Project	IEEE 802.16 Broadband Wireless Access Working Group < http://ieee802.org/16 >	
Title	EQP Removal	
Date Submitted	2007-11-01	
Source(s)	Ken Stanwood NextWave Wireless	Voice: +1 858 480 3327 E-mail: kstanwood@cygnuscom.com
Re:	Letter Ballot 29 Task Group Review of P802.16h/D3	
Abstract	Based on simulation results of enhancements added last meeting EQP and aEQP are not necessary.	
Purpose	Remove unnecessary features.	
Notice	<i>This document does not represent the agreed views of the IEEE 802.16 Working Group or any of its subgroups. It represents only the views of the participants listed in the "Source(s)" field above. It is offered as a basis for discussion. It is not binding on the contributor(s), who reserve(s) the right to add, amend or withdraw material contained herein.</i>	
Release	The contributor grants a free, irrevocable license to the IEEE to incorporate material contained in this contribution, and any modifications thereof, in the creation of an IEEE Standards publication; to copyright in the IEEE's name any IEEE Standards publication even though it may include portions of this contribution; and at the IEEE's sole discretion to permit others to reproduce in whole

Figure h5—One 802.16 System Coexisting with Non-802.16 Systems

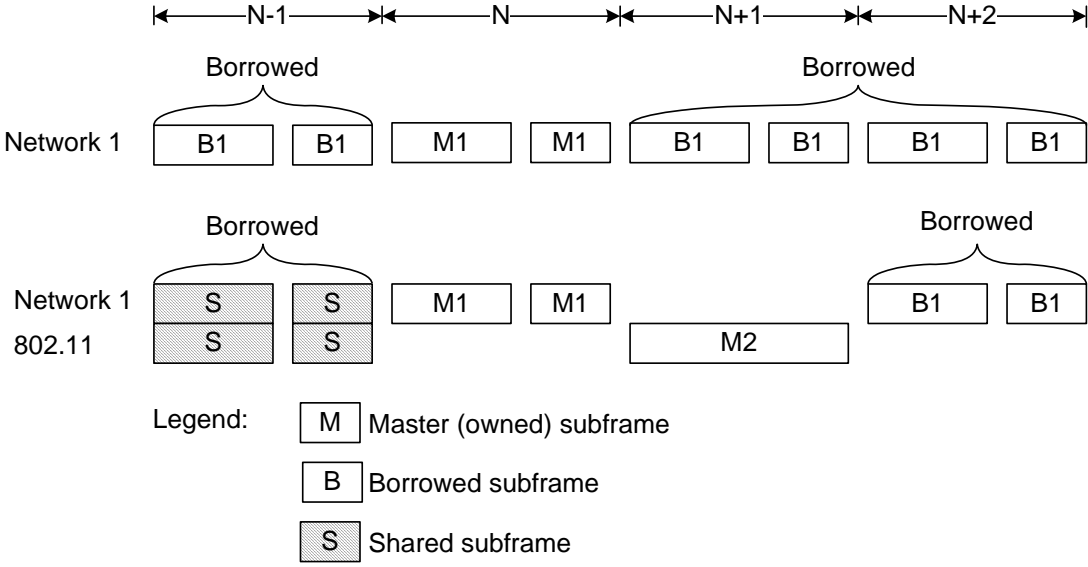
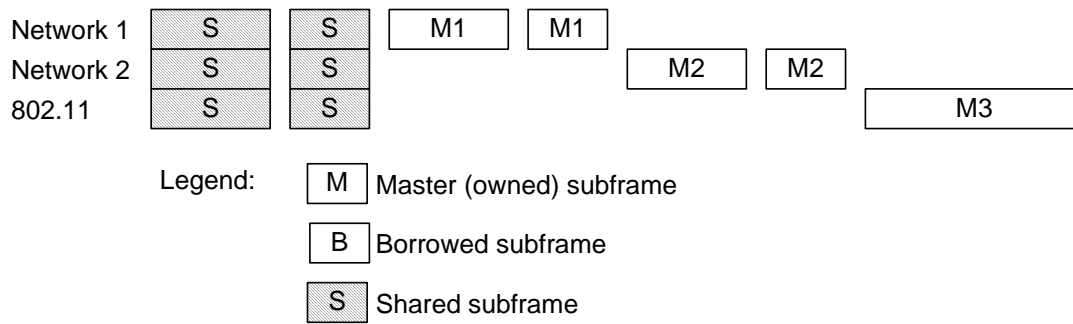
If a single 802.16 system is sharing with a non-802.16 system such as 802.11, the 4 frame sequence would transition from just the 802.16 system to being shared with a non-802.16 system as shown in Figure h 5. If two 802.16 systems were to coexist with a non-802.16 system, the structure would appear as in Figure h 6. In these cases, the attempt is to give the non-802.16 system ample opportunity to transmit while maximizing regularity of the 802.16 system's opportunities. In both cases, the shared frames need not be completely given up to the non-802.16 systems but can be shared through use of the Listen Before Talk (LBT) feature described in 6.4.3.5. Attempts to use the shared frames shall be on a round robin basis between 802.16 systems since their synchronization defeats using LBT to avoid each other. Since 802.11 and other non-802.16 technologies do not have a concept of "owned" frames and do not realize they are "master" of certain time periods, there is a possibility of interference even in master frames. Therefore, 802.16 systems shall use the LBT mechanism prior to transmitting in master frames if there is reason to believe a non-802.16 system is co-channel. Additionally, aEQP shall be used to allow entry of the non-802.16 systems.

Figure h7—EQPs Map Relevance = n+1

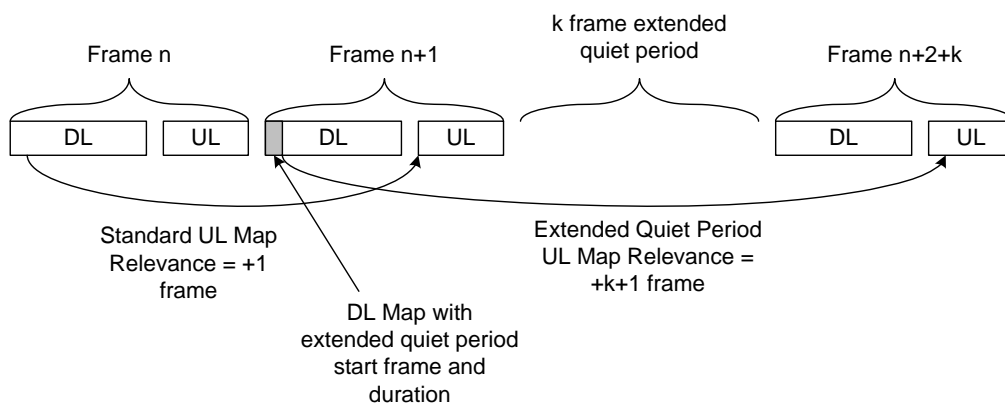
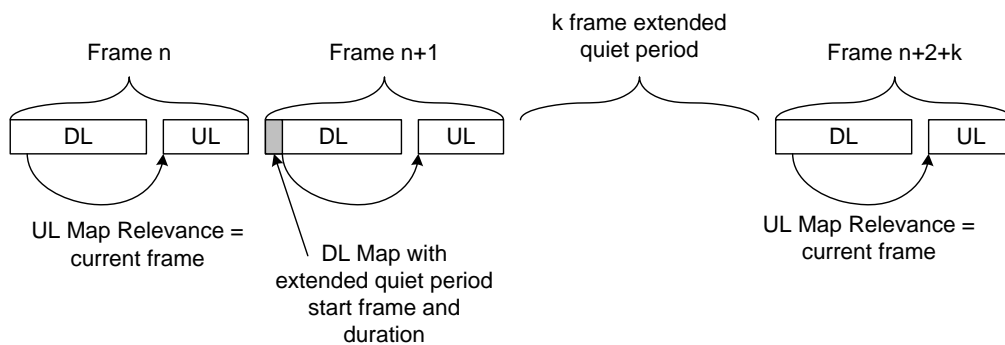
6.4.2.3.5 Extended Quiet Periods (EQP)

Extended quiet periods (EQP) are periods of an integer number of frames during which both uplink and downlink transmission is suspended. The primary purpose of the EQPs is to give other uncoordinated users of non-exclusively assigned or non-exclusively licensed bands reasonable opportunity to operate when an alternative channel is not available. While not all future technologies with which 802.16 systems may need to coexist can be identified today, 802.16 systems are expected to coexist with other 802.16 systems and with 802.11 systems.

Since 802.16 systems have the capability to fragment SDUs, EQP duration of a single frame is sufficient for allowing another 802.16 system access to the spectrum. In fact, the synchronized sharing of the channel as described in section 6.4.2.3.4 is a form of synchronized EQP between two or more 802.16 systems. For 802.11 coexistence, the quiet period duration should be chosen to allow the maximum duration 802.11 transmission allowed in the band. For 802.11y, this is 4ms. For 802.11a, b, and g systems the maximum PHY PDU (PPDU) using the 802.11 5.5 Mbit/s PHY mode is used as a reference. 802.11 systems can operate with one of three channel bandwidths—20 MHz, 10 MHz, or 5 MHz. This bandwidth affects the transmission duration of a maximum length 802.11 PPDU. The minimum EQP durations for various channel bandwidths are shown in Table h 132g. The number of integral frames required is a function of the chosen frame duration for the 802.16 system. 802.16 BS and SS shall retain respective DL and UL synchronization over the period of EQP. The use of the EQP protocol shall recognize appropriate use of the Lost DL/UL MAP Interval parameter in table 342.

Figure h9—Adaptive EQP (with example parameter numbers)

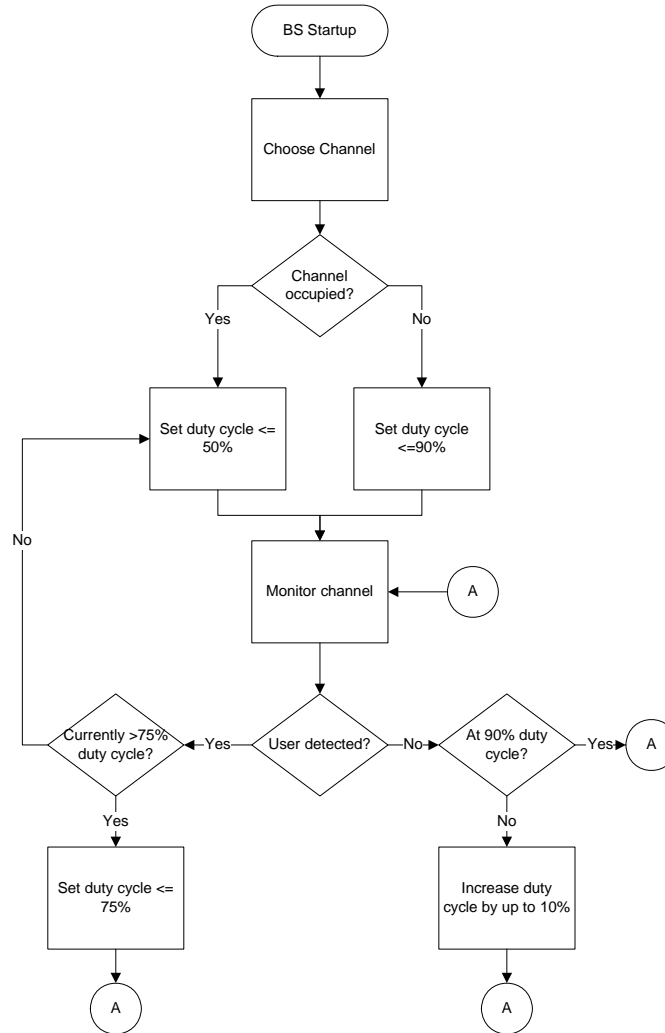
6.4.2.3.6 Adaptive EQPs (aEQP)

There may be bands where the probability of presence of other users in a specific area is low. This situation may occur where there are very few users present in the band, for example, in a particular rural geographical location. In these cases, it is important to not waste bandwidth catering to non-existent users of the band. When EQPs are used in a non-exclusively assigned or licensed band, a BS initially offering service shall perform an initial (see 6.4.2.3.2)

scan and pick the best channel. (or this may be configured based on measurements made outside the scope of the 802.16 system or based on collaboration between operators). Based on this choice, if the channel is thought to be free of other users, the BS shall set the initial duty cycle to no more than `max_duty_cycle`. If another user was detected, the BS shall initially operate a duty cycle of no more than `share_duty_cycle`. Duty cycles are measured over a 1 second period. This duty cycle can be achieved a number of ways. For instance a 50% duty cycle can be achieved: with the use of every other frame, n frames on and n frames off, or operate in $n/2$ of n frames, etc. The method of achieving the duty cycle shall be left for vendor differentiation which increases the likelihood of randomization of the algorithm of two different BS from two different operators which in turn increases the likelihood of their ability to eventually detect each other or an SS associated with the other BS. If the 802.16 system is already sharing the channel with another 802.16 system as described in section 6.4.3.2 the duty cycle shall be calculated based solely on the master and borrowed frames used by the particular system. Refraining from transmitting during a master or borrowed frame of another system shall not count as having been quiet for the purposes of an EQP.

If after a prolonged period which is band specific in duration, the BS and its associated SSs have not detected other users in the band through measurement and reporting during EQPs coupled with measurement and reporting as performed for DCS (see 6.4.2.3.2) then the BS may increase its duty cycle by `duty_cycle_step`. The duty cycle shall not increase above `max_duty_cycle` as measured over a 1 second period. The BS shall continue to measure and shall continue to instruct SSs to measure and report using the EQPs and the DCS (see 6.4.2.3.2) mechanism. If a SSU is detected, the band specific regulations shall be followed. If another user that is not a SSU is detected the BS shall reduce its duty cycle to at most `intermediate_duty_cycle` within 10 frames of the BS becoming aware of the detection. If the detected user persists, the BS shall reduce the duty cycle to at most `share_duty_cycle`. The flow is shown in *Figure h-9* using example parameters: `share_duty_cycle` = 50%, `intermediate_duty_cycle` = 75%, `max_duty_cycle` = 90%, and `duty_cycle_step` = 10%.
